Rezoning Transportation Analysis

Petition Number: 2024-004

Date	Description
2-21-24	First Review (JP)
3-20-24	Second Review (JP)

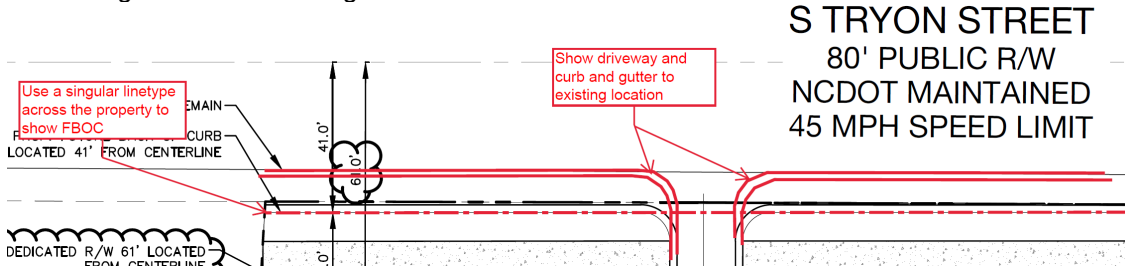
- 4. **Outstanding Comment 3.20.24:** In coordination with NCDOT, revise site plan and conditional notes to install a right turn lane into the site with 50' of storage.
